Livestock Plaza/Sheep Barn

Addendum Issue Date: 8/8/24

The following changes, revisions, or clarifications shall be made to the drawing documents.:

SHEET: **A7.2**

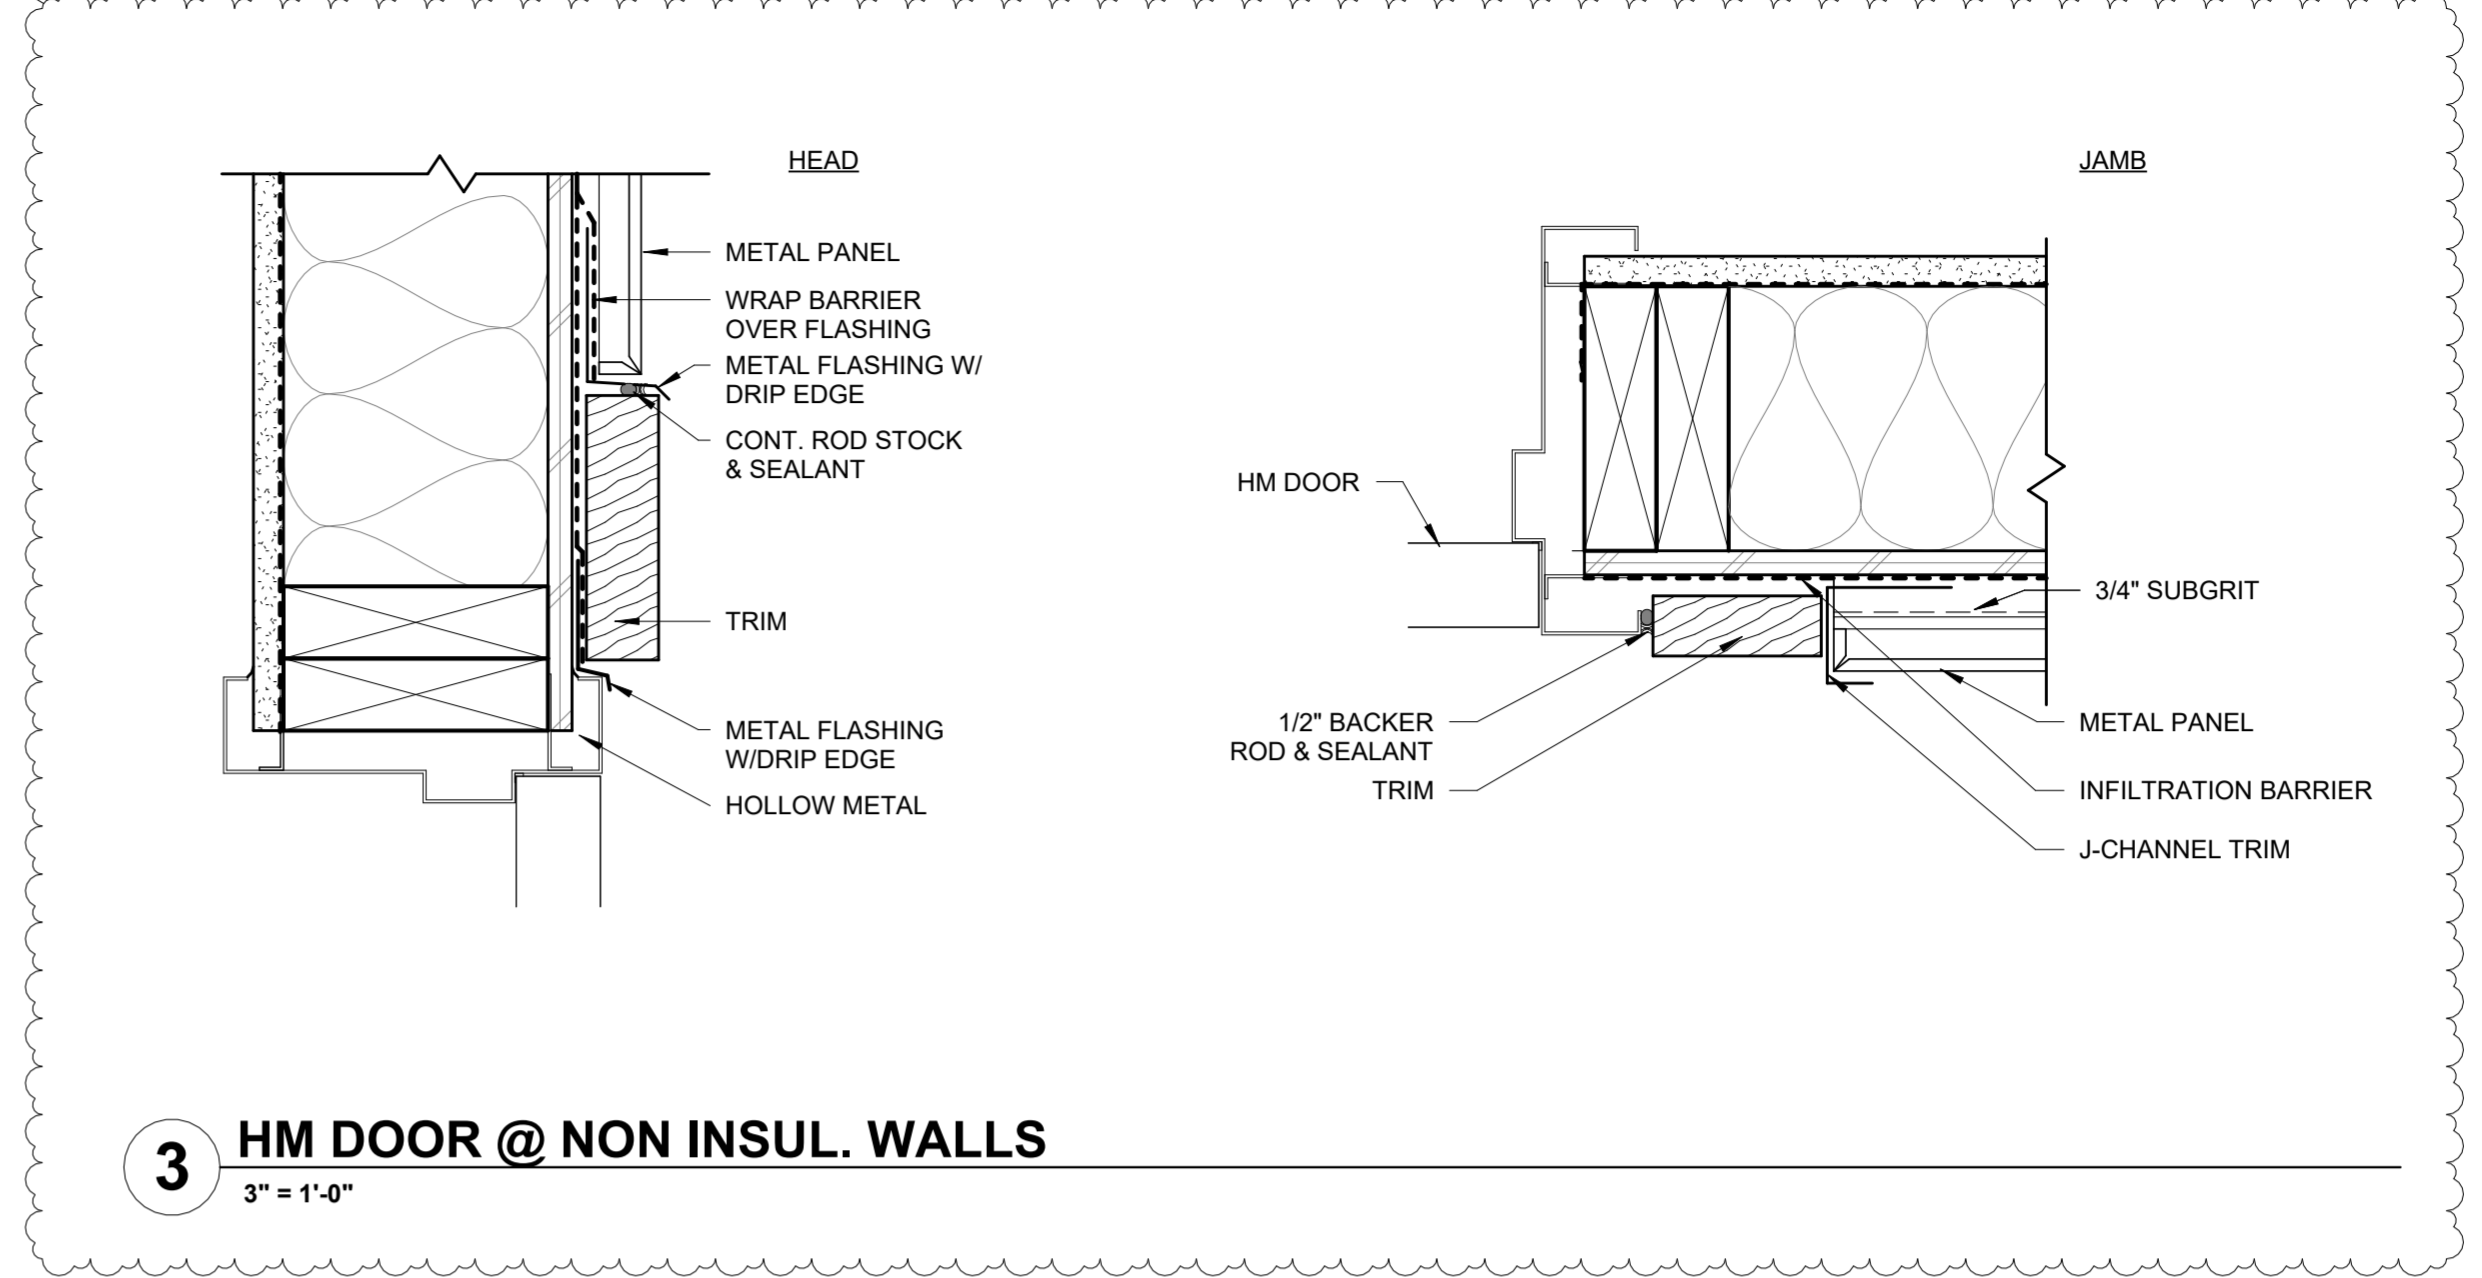
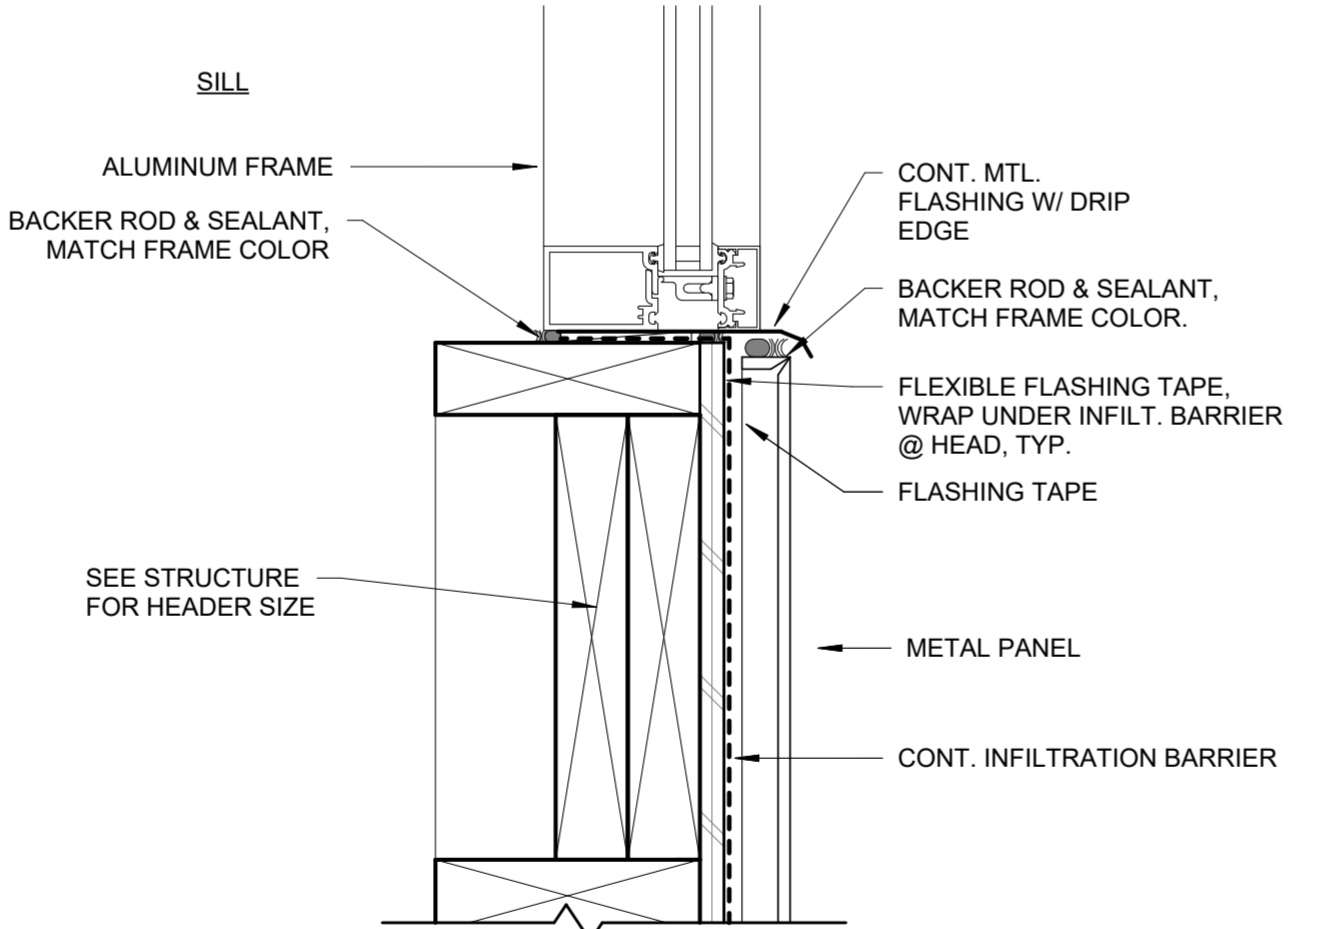
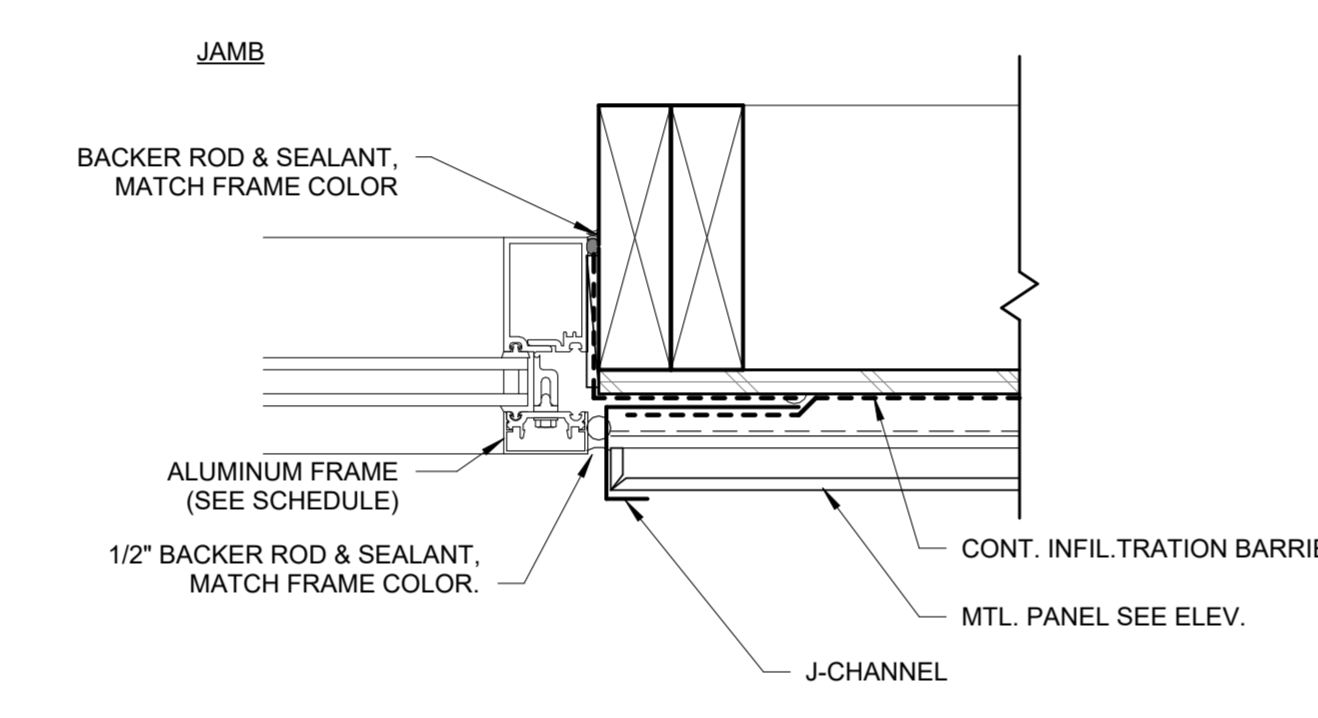
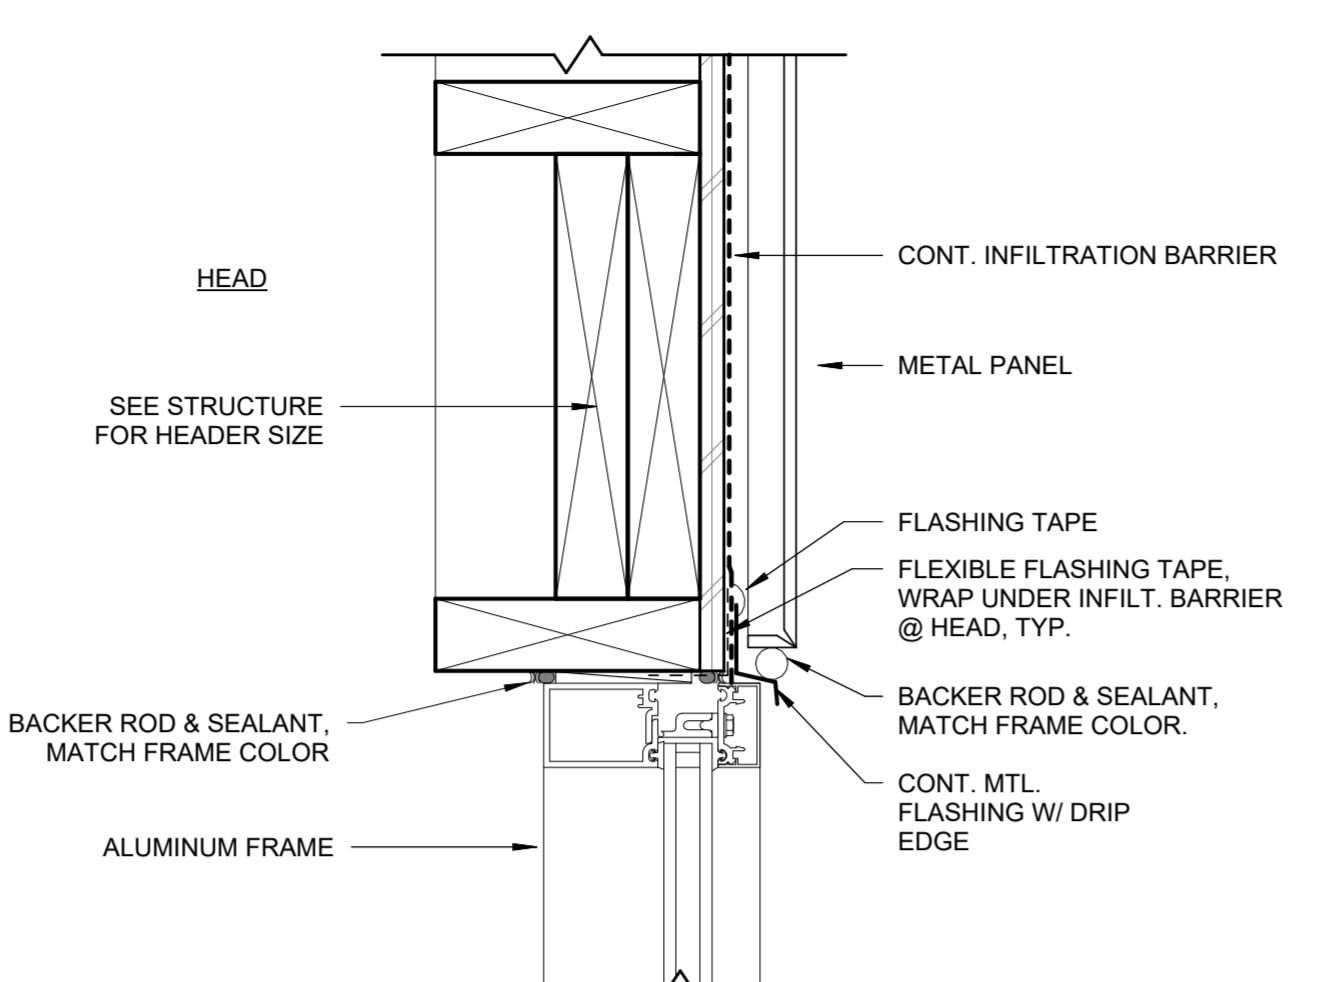
Sheet A7.2 – Door and Window Details:

Door detail revised.
